LOCAL HISTORIC DISTRICT: Dilworth

PROPERTY ADDRESS: 315 East Boulevard

SUMMARY OF REQUEST: New construction

Charlotte Historic District Commission Case 2017-393
HISTORIC DISTRICT: DILWORTH
NEW CONSTRUCTION

HDC-15

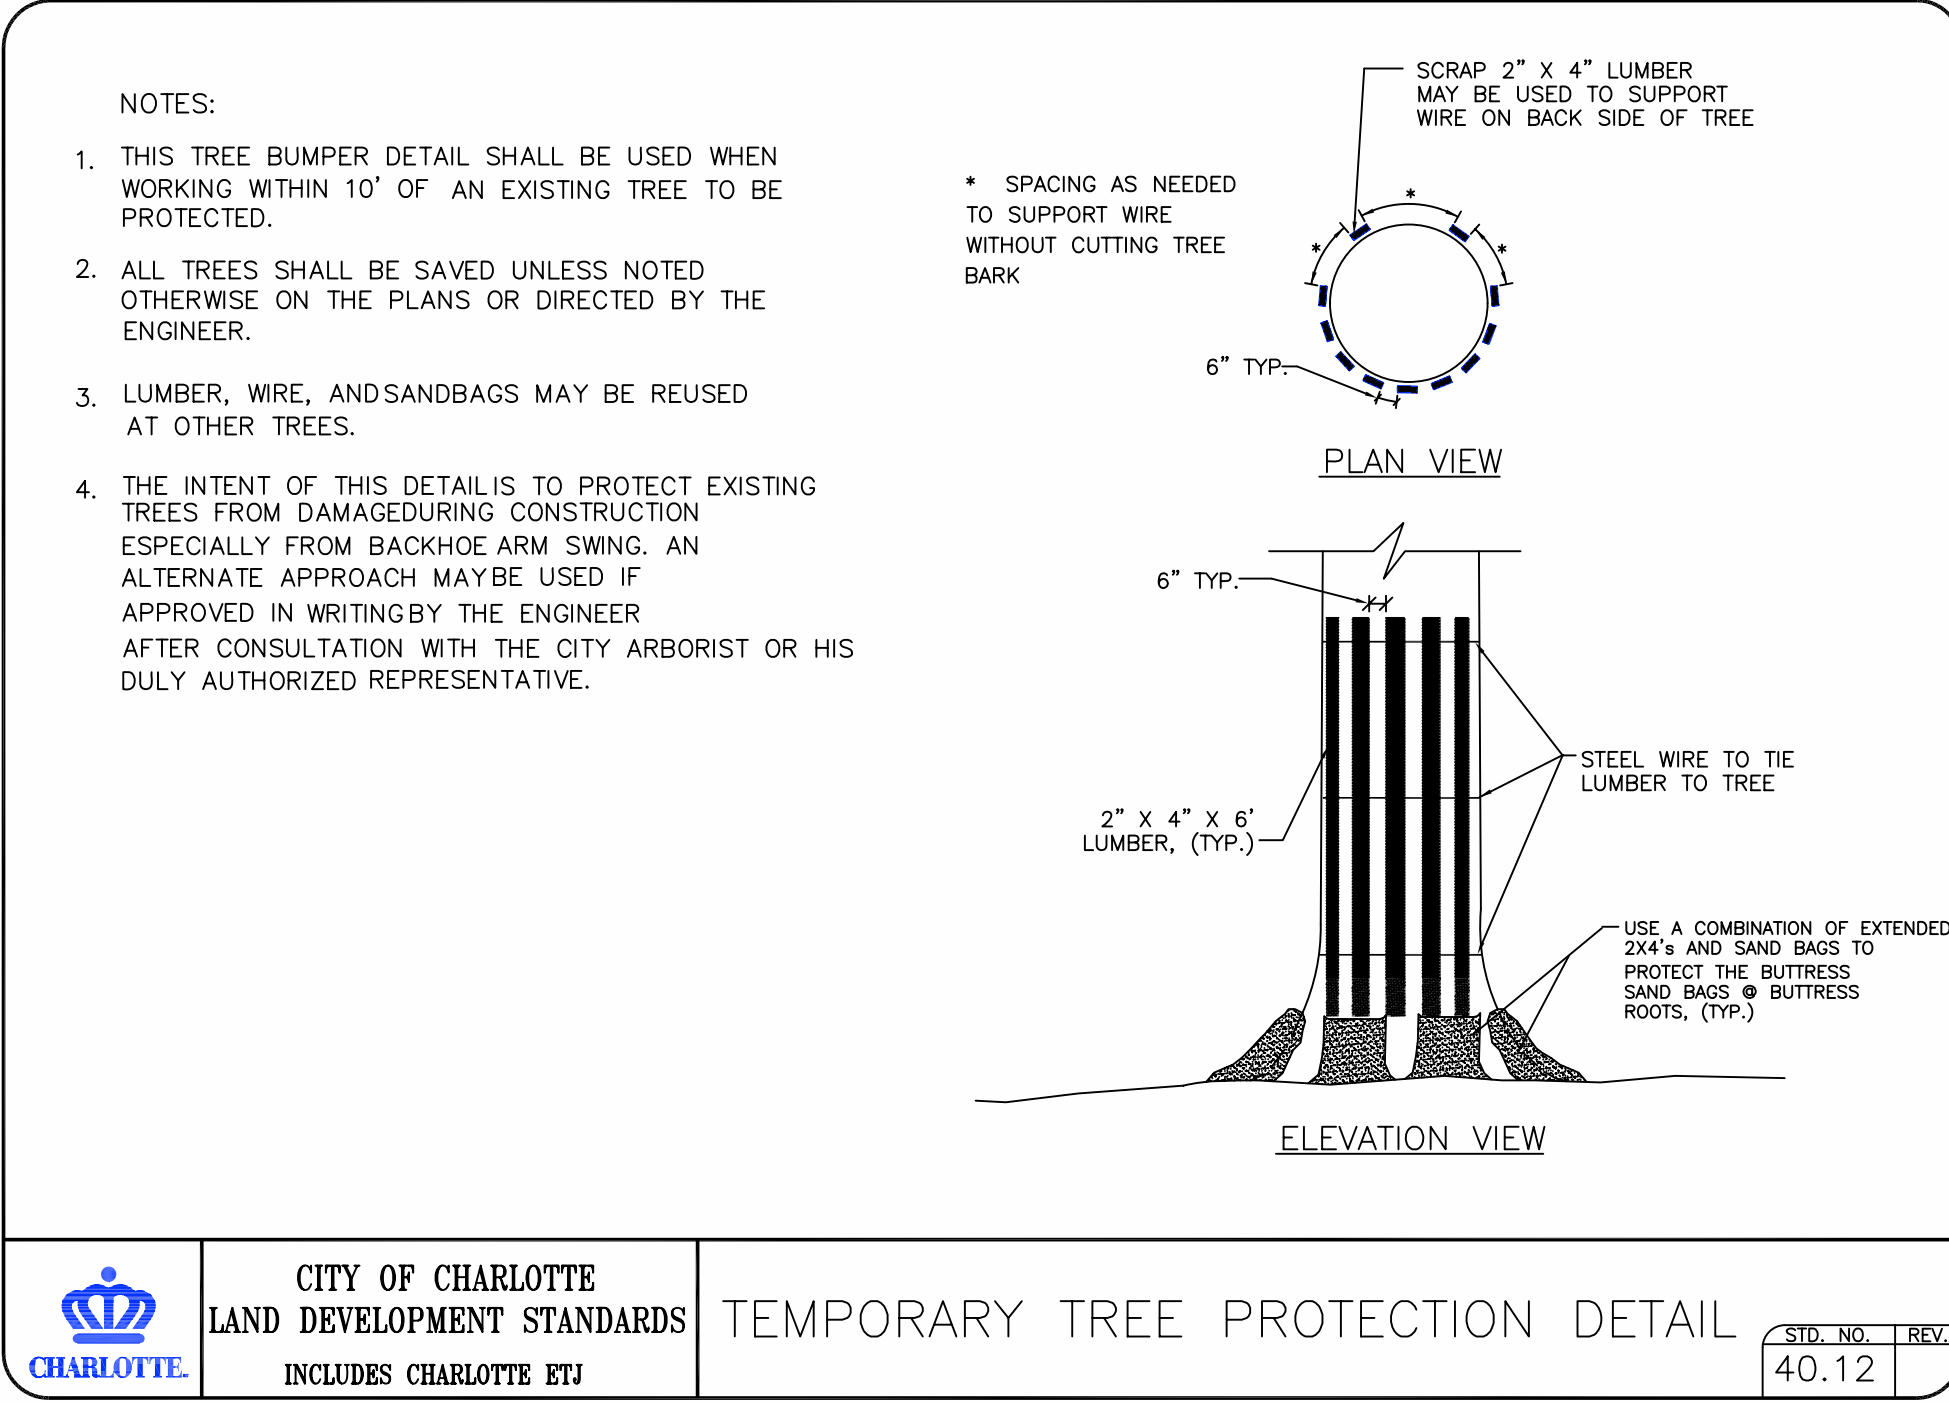
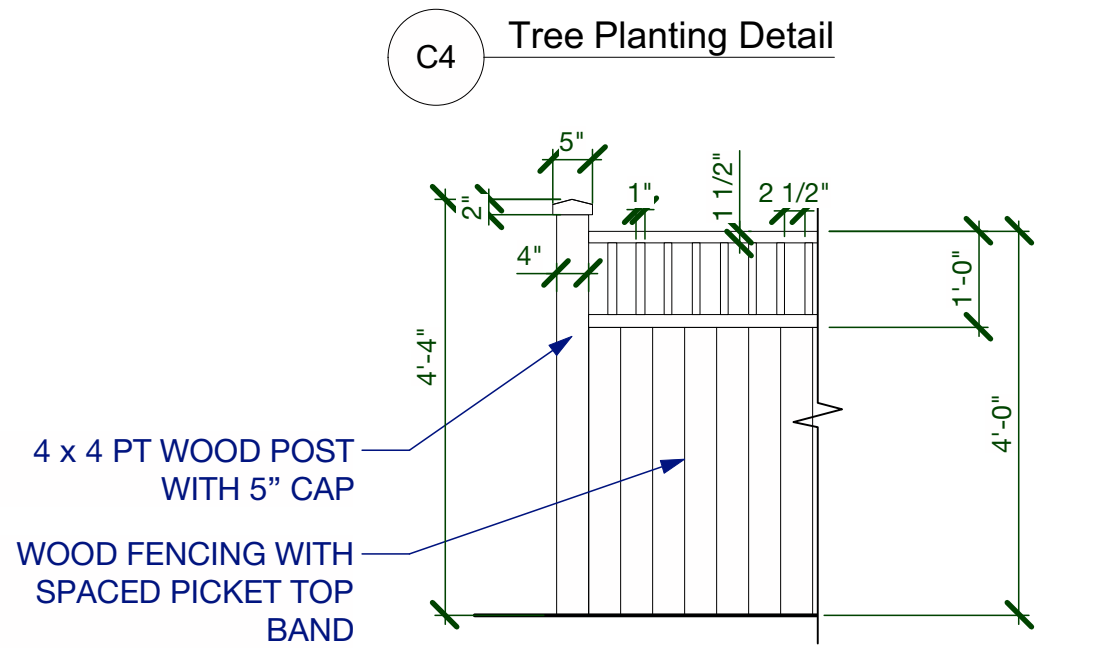
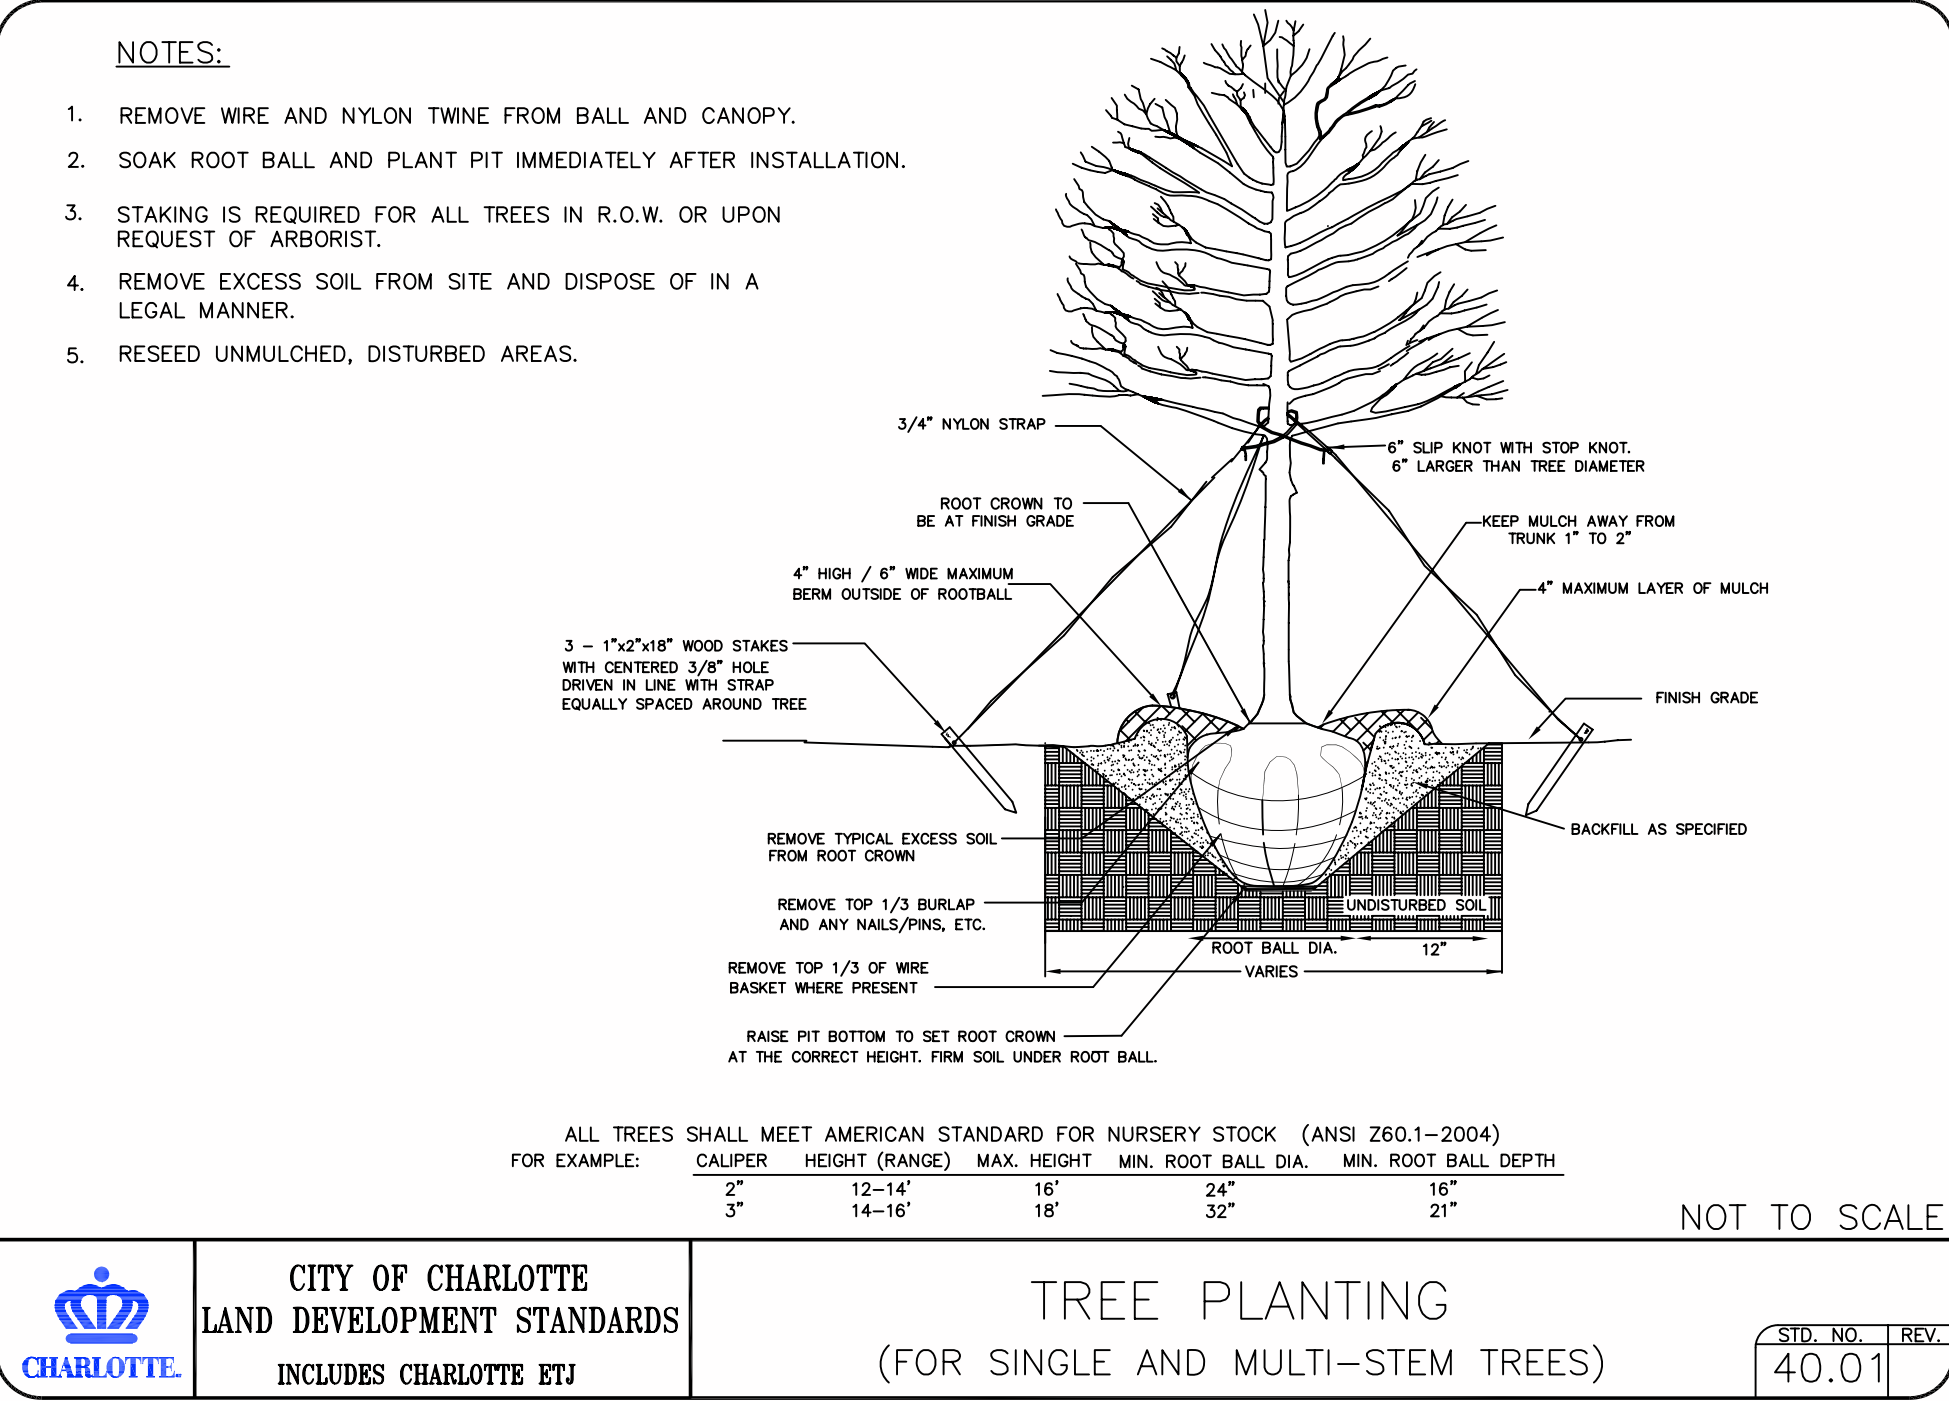
The application was continued from July for the following: 1) Provide an additional site plan that shows a 20' easement abutting the parking lot, revised fence and gate location, 2) landscaping plan, 3) tree protection plan, 4) Provide screening for AC units, 5) Eliminate the window aprons, 6) Consider design options for the elevation facing 315 East Boulevard.

- Provide an additional site plan that shows a 20' easement abutting the parking lot, revised fence and gate location
- Landscaping plan
- Tree protection plan
- Provide screening for AC units
- Eliminate the window aprons
- Consider design options for the elevation facing 315 East Boulevard

1. Sheet #HDC-15 – The additional 10' easement has been included.
2. Sheet #HDC-15 – AC screening is included
3. Sheet #HDC-15/16 – Landscaping and tree protection plan is included
4. Sheet #HDC-20 – East Boulevard elevation has been revised
5. Sheet #HDC-15 – Window trim has been revised
